PRODUCT CHANGE NOTIFICATION

SCHURTER ELECTRONIC COMPONENTS

Product hierarchy no. *				Part no.	SBU	Type / Description	Customer part no.
SBU	PG	PGU	Type				
02	006	018	0000001544	See list below	Power Entry Modules with Filters	DD22

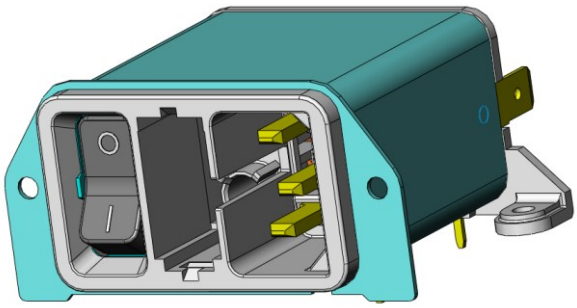
Enlarging of the fusedrawer slot.

Fusedrawer slot enlarged.

New

Old

Implementaion of V-Lock cord retention function.
Precondition: new fusedrawer required (see PCN 0118.2133)

Form: New form is fully backwards compatible (can be used with old fusedrawer, see PCN 0118.2133).

Function: The new expanded slot allows applying V-Lock cord sets for cord retaining (new fuse drawer necessary).
